Subject: Description of Permissive Change

FCC ID: QKLM12V2

Model Number: Redline 360c

Original PCBA design

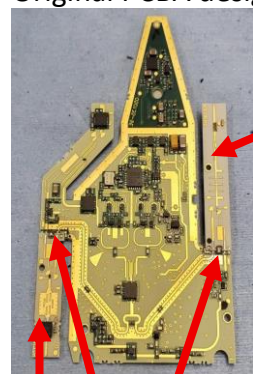
1. The Analog RF section was originally in three separate PCB assemblies. The revised design to improve manufacturing is now a single PCB that contains all the original circuits plus preserves to the greatest extent possible the component layout and respective locations.

Separate  
PCBA

Separate  
PCBA

Solder bridge connections

Revised PCBA design

One continuous PCBA
